VILLAGE OF GERMANTOWN
N112 W17001 MEQUON ROAD, GERMANTOWN, WI 53022

MEETING:	PLAN COMMISSION
DATE AND TIME:	MONDAY, June 13, 2022 6:30 p.m.
LOCATION:	Germantown Village Hall Board Room, N112 W17001 Mequon Road

SITE PLAN REVIEW

Mike Faber, agent for Capstone Quadrangle Development Company and CQ WI 2021 LLC, property owner, is requesting approval of revised site development plans (grading and landscaping) for the 203,580 sqft industrial building located within the Capstone 41 Business Park and Holy Hill Road Gateway District.

SHEET
L-4
OF
L-5

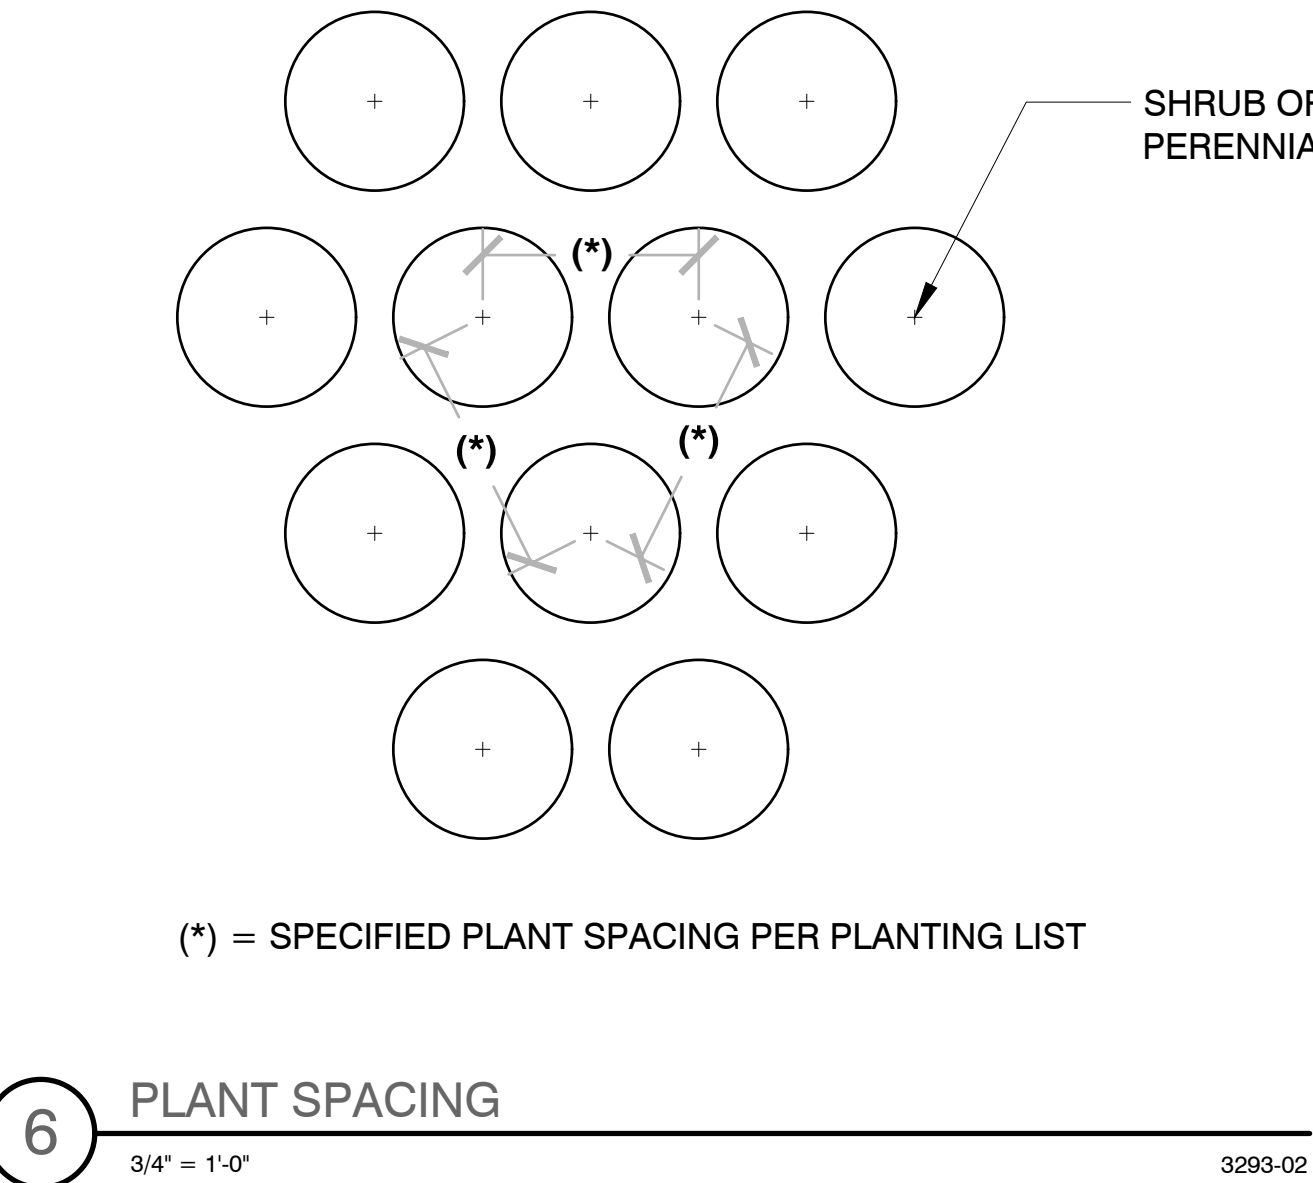
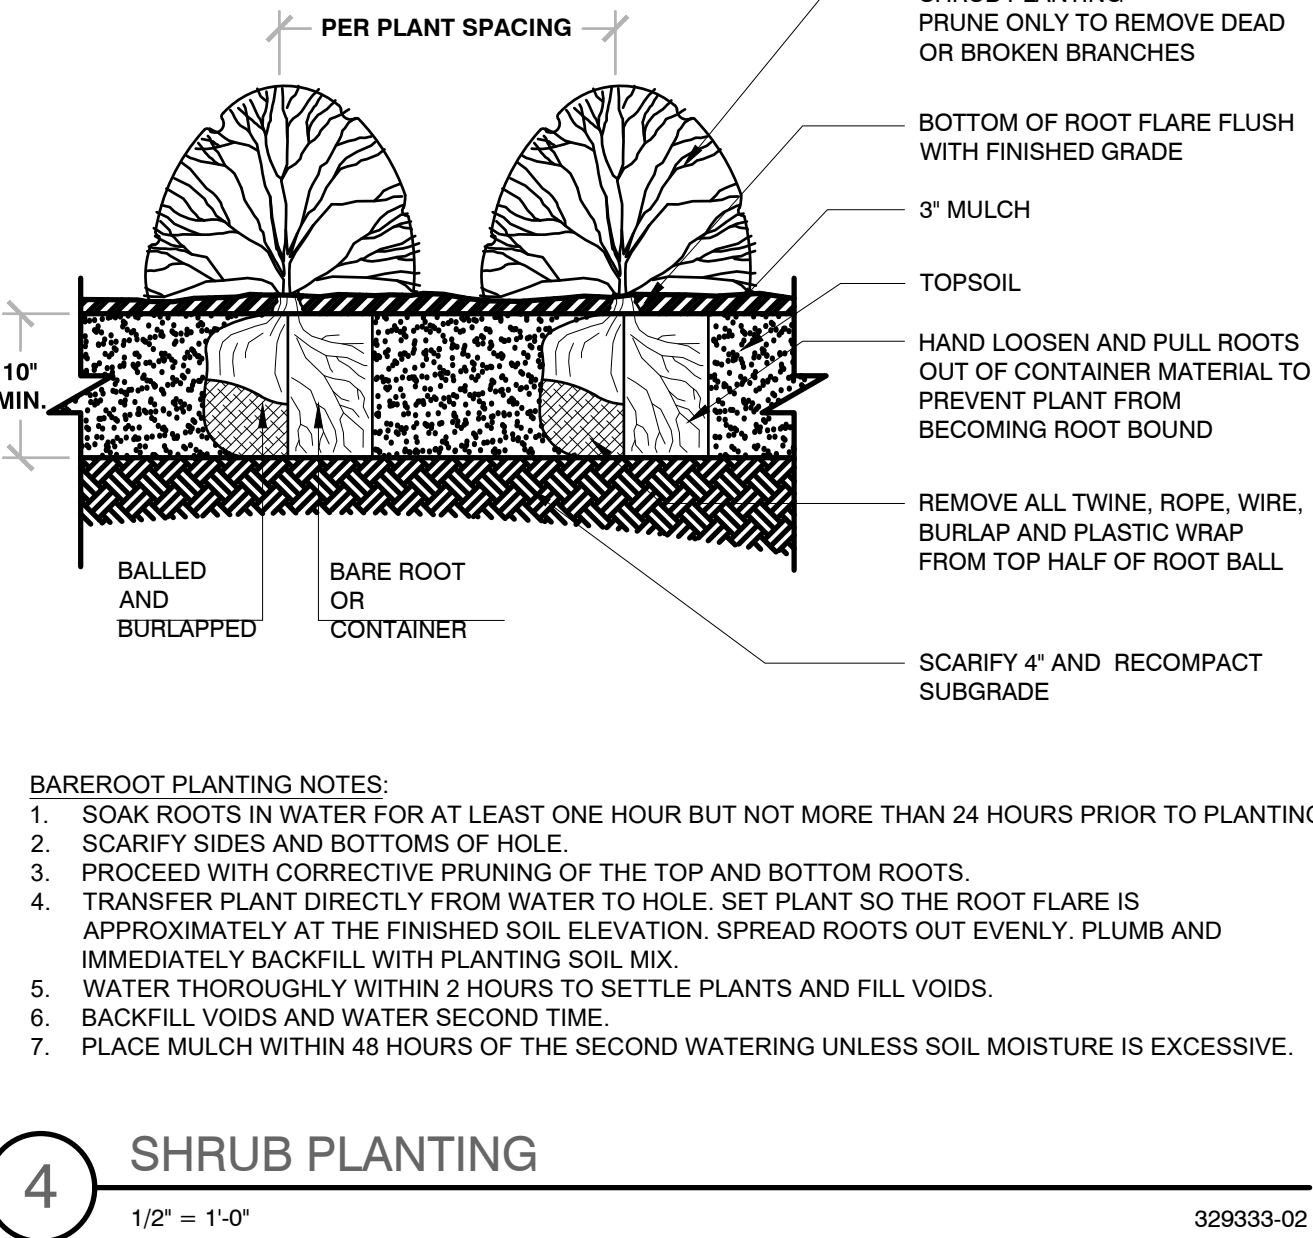
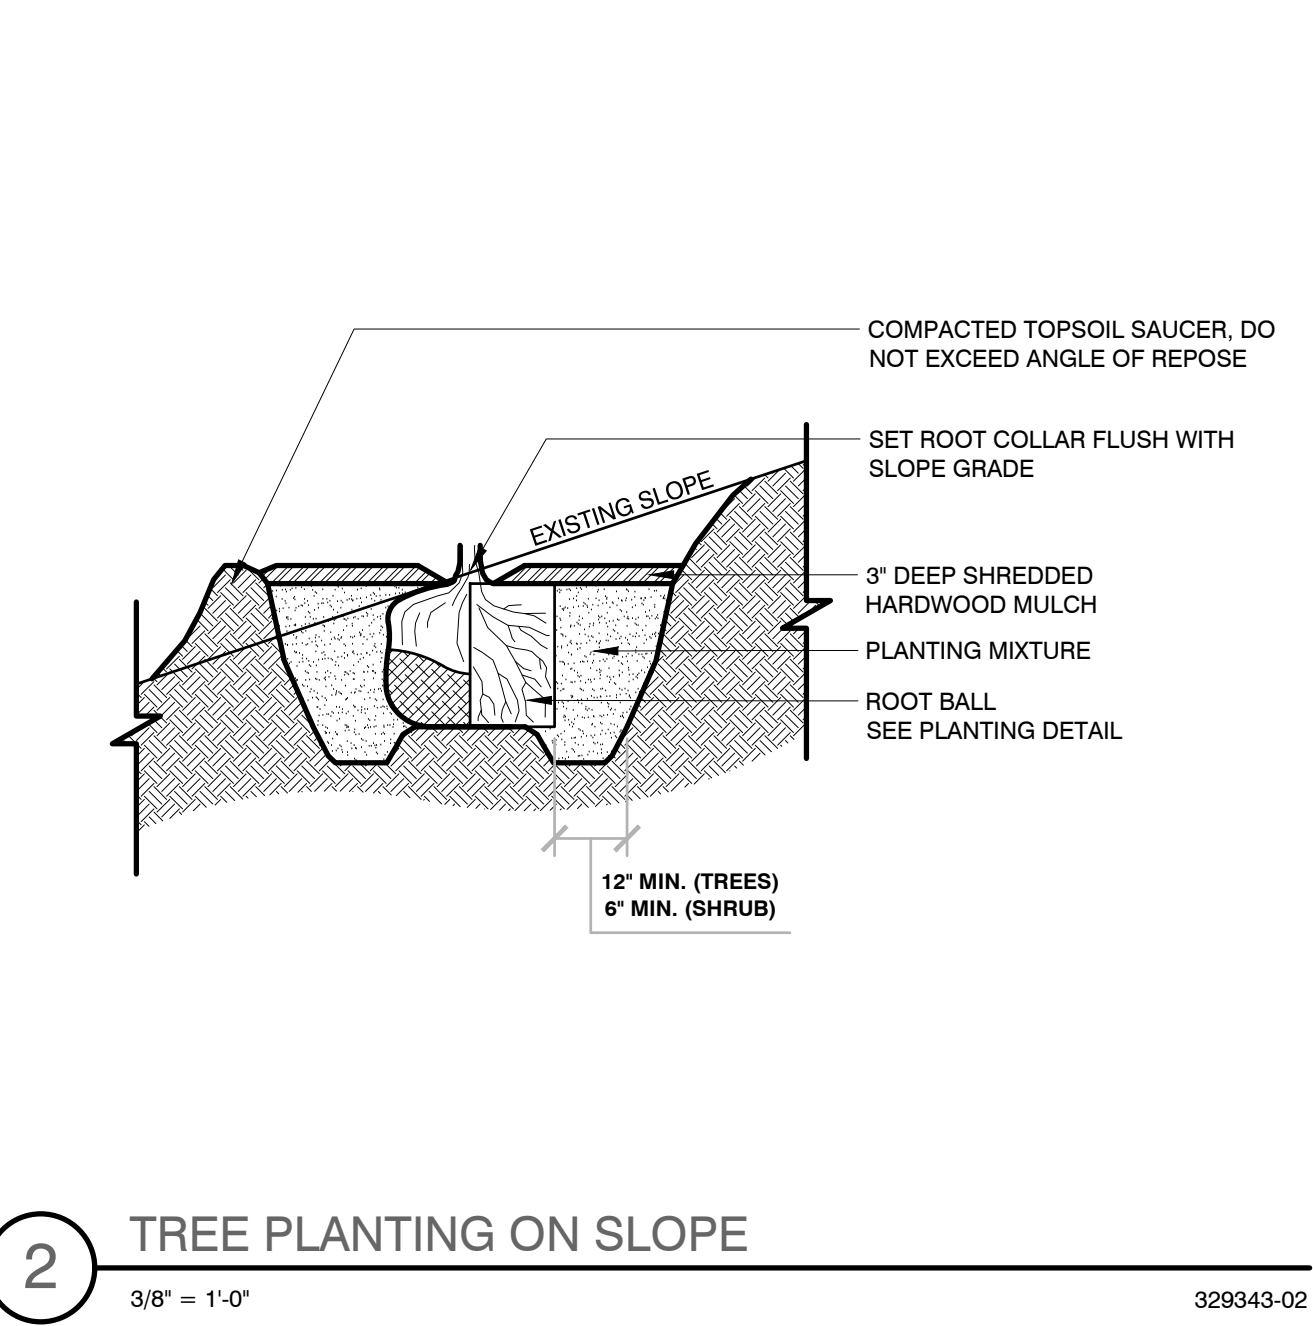
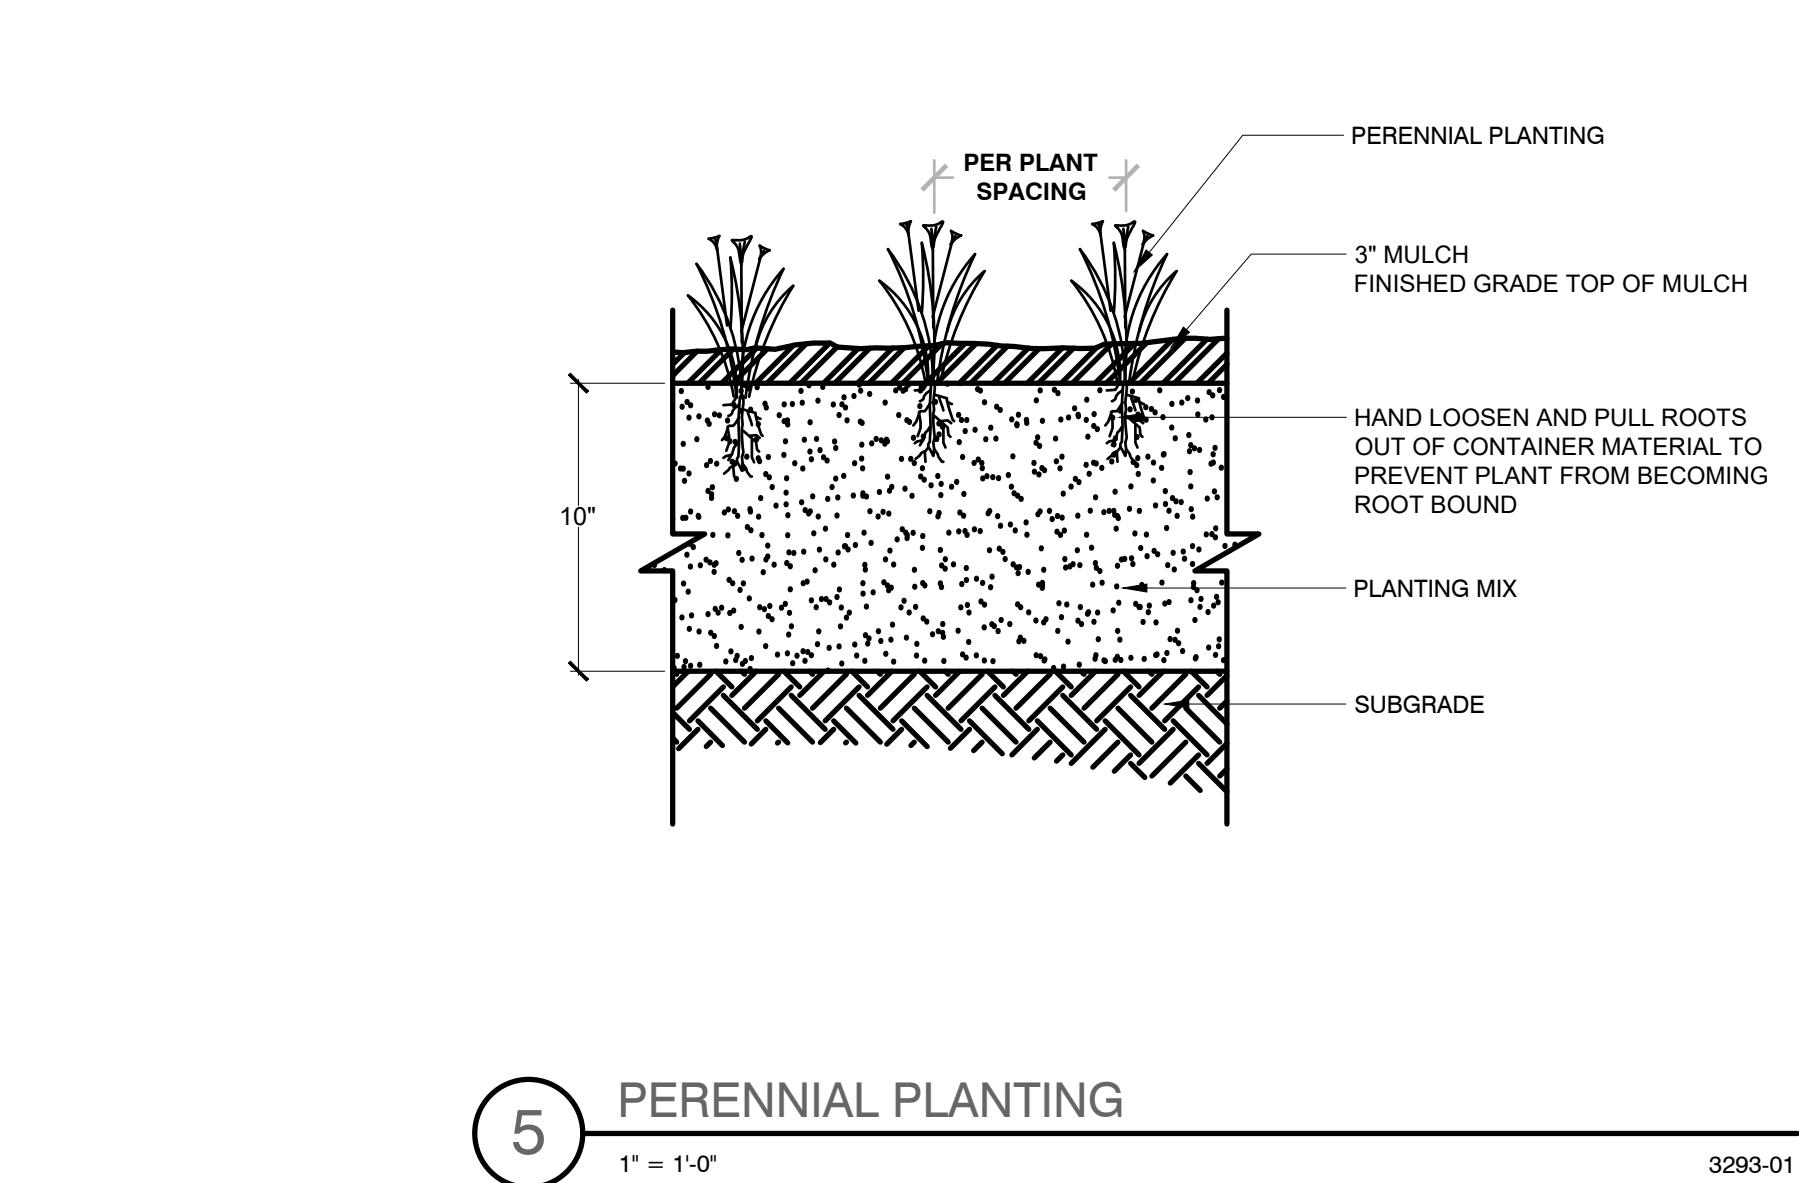
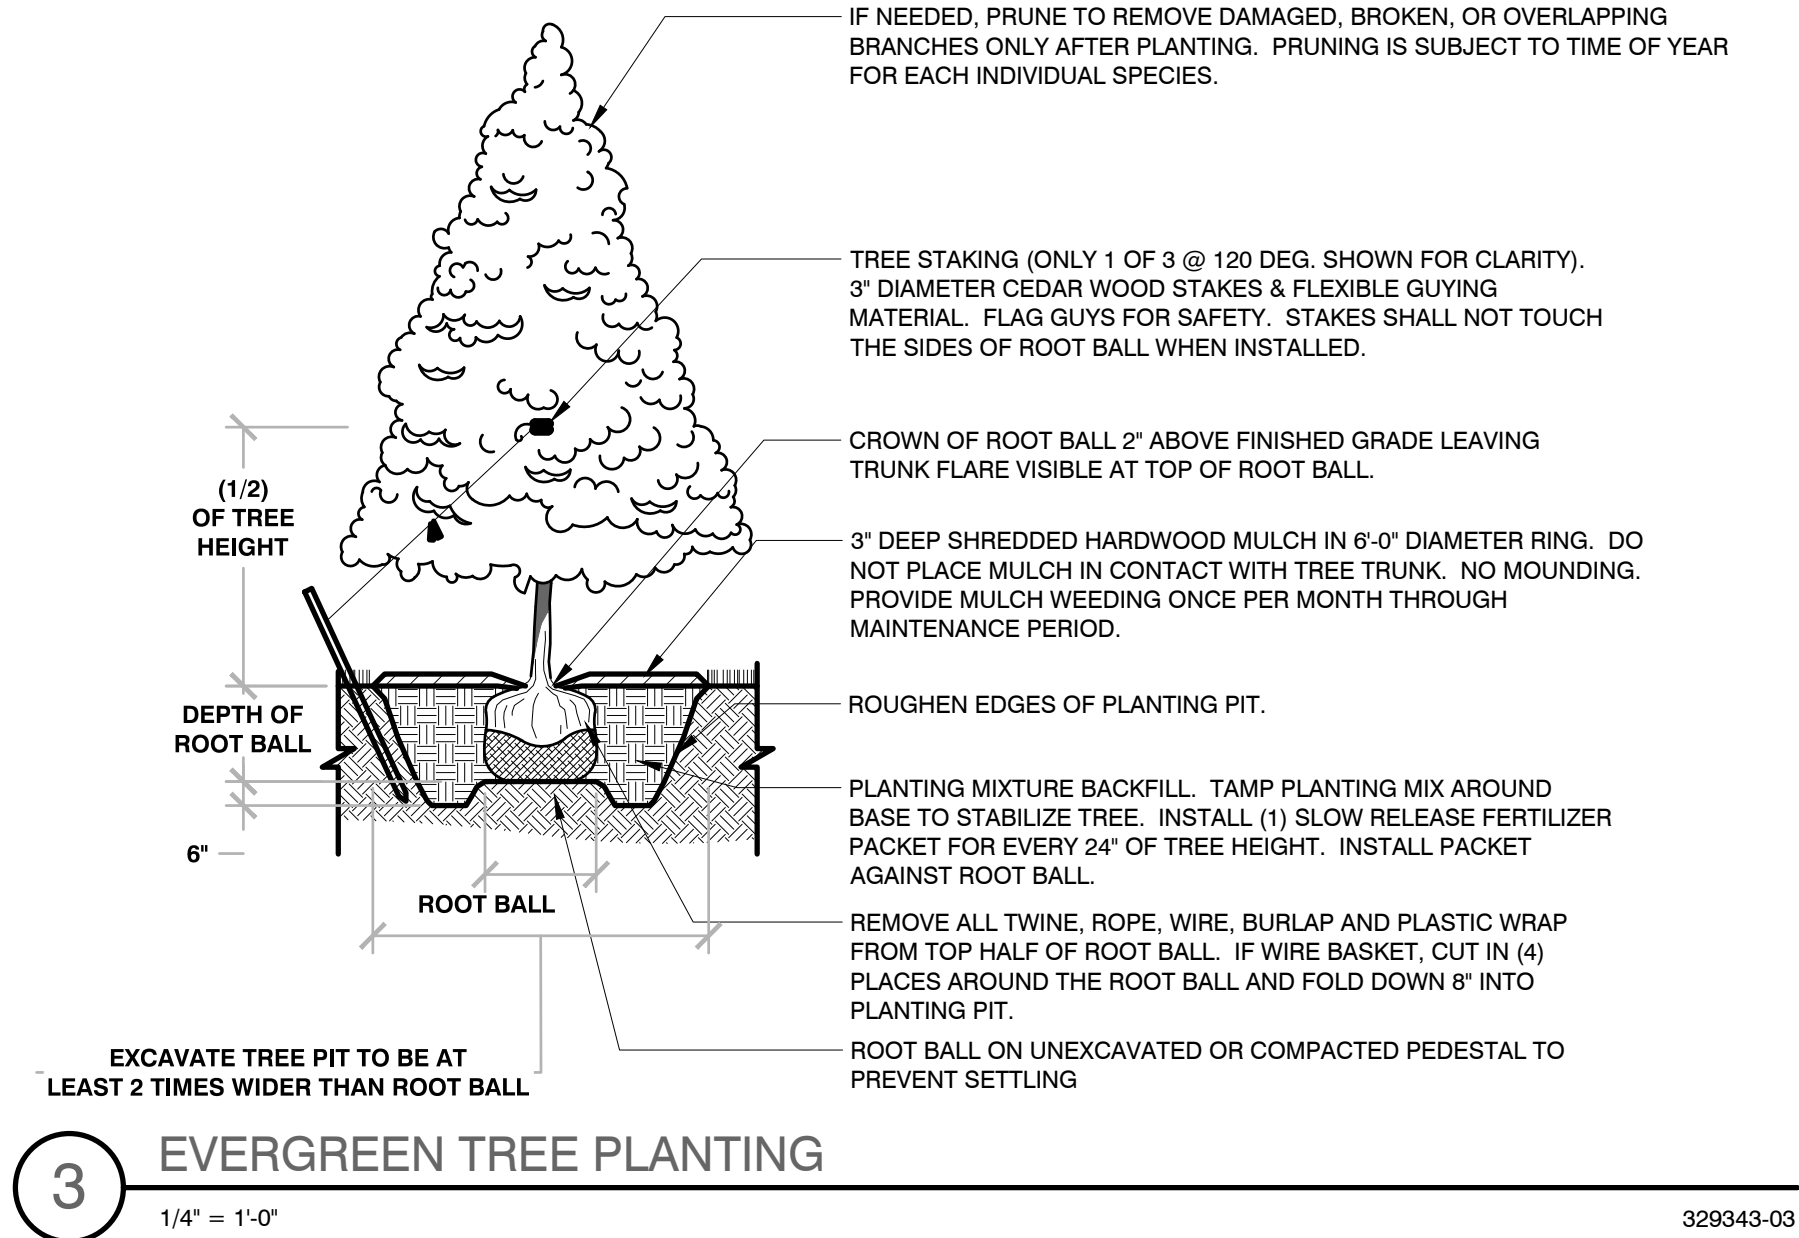
The Plan Commission determination on August 9, 2021 also required that we supplement the landscape material quantities along our Holy Hill Road frontage on the berm, in order to help better screen the truck court, and also asked if it was possible to provide a “drive-by” video rendering to help the Village assess what the landscape density would be (at both installation and at a more mature size at the 5-6 year point). We have modified the landscape plantings by adding good quantities, and we think the drawings, renderings, and videos convey that the truck court is suitably screened. Due to the grades of Holy Hill Road relative to the grade of the truck court, even prior to raising the berms, the most important visual range is the 0’ – 10’ above the berm height. Thus the most beneficial of the added plantings are in that “relevant zone”.

Our landscape architect (Dale Bunderson of Pinnacle Engineering Group) advises that this planting density is as close together as he would recommend for normal plant health. It would be possible to pack more in, but Dale states that is generally frowned upon, because the trees grow into each other, competing for sunlight and moisture / nutrients, and in the long run would not be as healthy nor live as long as trees with proper spacing for optimal health.

As shown in the revised plans, renderings and “drive-by” videos, additional plantings have been added along the west side of the truck parking/staging area, and, along to the north elevation abutting Holy Hill Road with modifications to the berm height and undulation. “Drive-by” videos along Holy Hill road at two different time intervals, at the time of planting g and at 5 years growth, have been prepared as requested by the Plan Commission.
